CITY PLANNING COMMISSION

- APPLICATION:
1. Environmental Determination
 2. Tentative Map to divide 17.4± vacant acres into 7 lots in the Townhouse-Planned Unit Development (R-1A(PUD)) zone.
 3. Special Permit to develop 250 condominium units known as Gateway Oaks, Unit 2 (Zon. Ord., Sec. 8-B-3)

LOCATION: Gateway Oaks Drive, approximately 500± feet north of Garden Highway

SITE INFORMATION
174-51

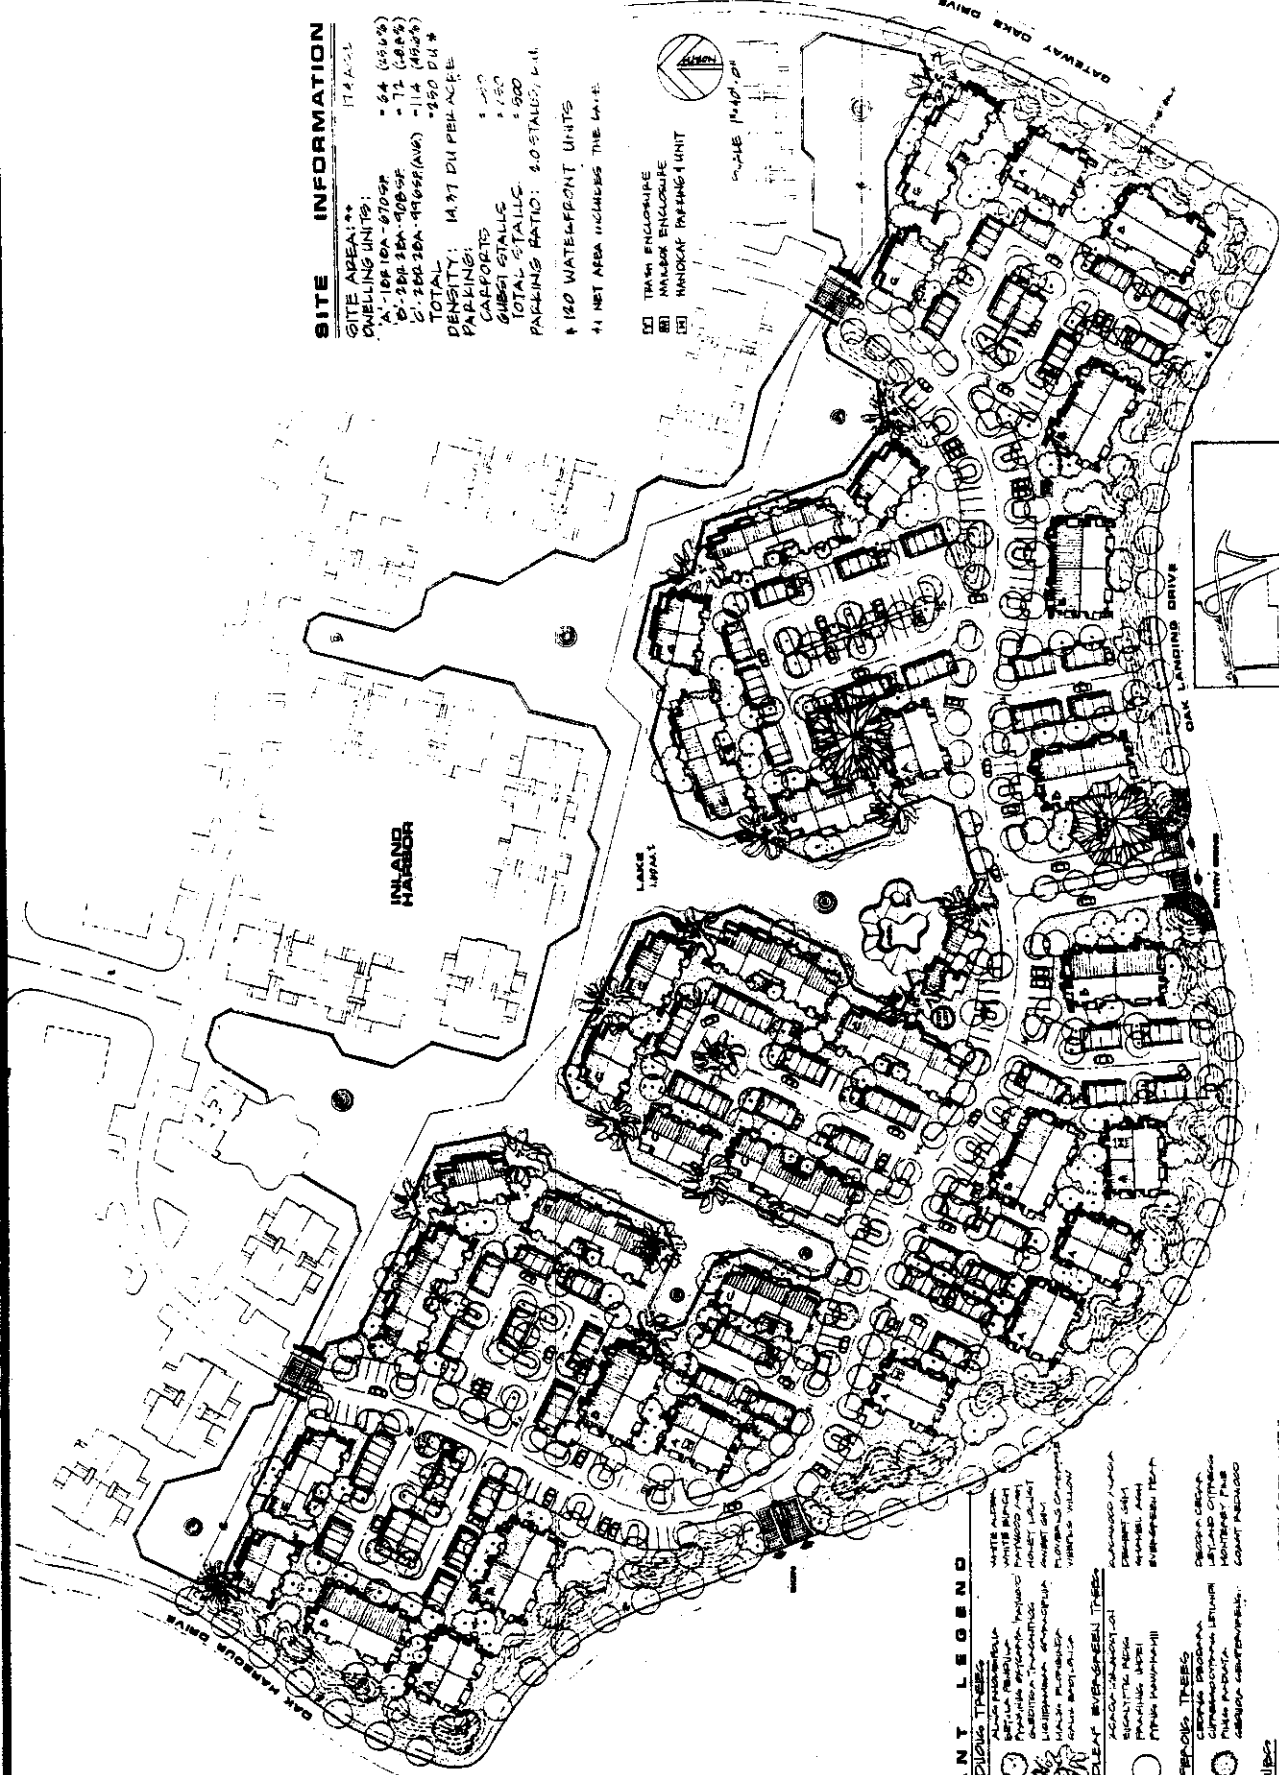
The proposed project provides landscape setbacks of 25 feet to 40 feet along Oak Landing and Oak Harbor Drives. The project provides off-street parking at a ratio of two spaces per unit. One-half of the spaces is covered. To insure consistency in landscape development throughout the project, and the incorporation of energy saving design elements in the site design, staff recommends that Exhibit A be adopted as a condition of approval.

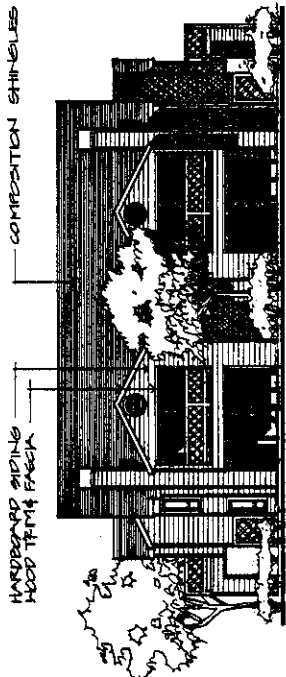
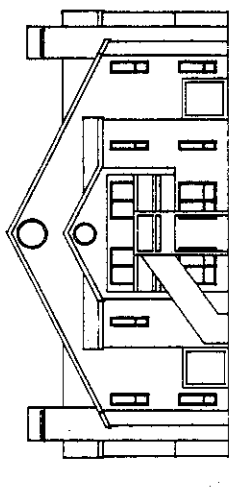
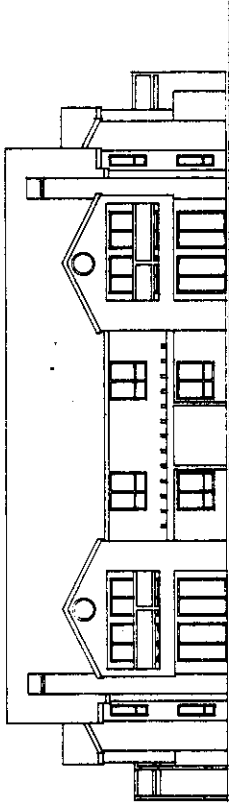
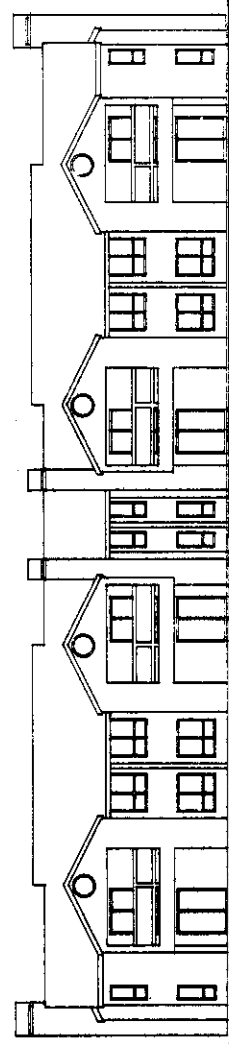
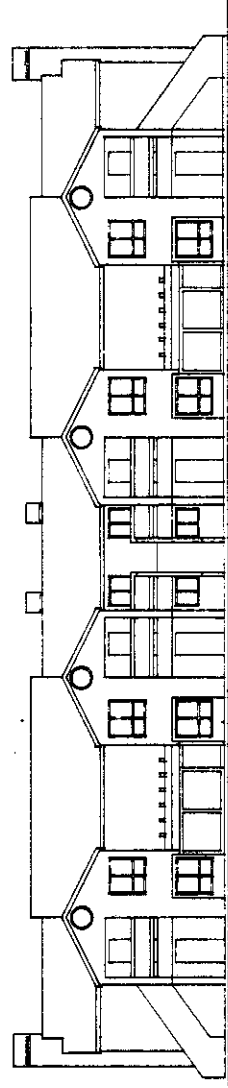
The units are two-story in height, constructed of horizontal wood siding, composition shingle roofs with the buildings proposed to be painted driftwood grey with white trim.

The color scheme is the same as that proposed for the 224 Phase I units. Staff requests that the applicant select a different color scheme for the second phase which would be complimentary, yet different from the Phase I units, to provide color diversity to the total project.

- a. The applicant shall adhere to the residential design criteria as outlined in Exhibit A;
- b. The applicant shall submit a sample color board for the Phase II units to the Planning Director for review and approval prior to issuance of building permit;
- c. A detailed landscape and irrigation plan shall be submitted for staff review and approval prior to the issuance of building permits. This plan shall incorporate the design elements as set forth in Exhibit A;
- d. The applicant shall submit a sample of the roofing materials to the Planning Director for review and approval prior to issuance of building permit;
- e. A homeowners' association shall be formed and CC and R's developed assigning responsibility of maintenance of the lake area to the homeowners' association. CC and R's shall be approved by the Public Works Director and City Attorney.
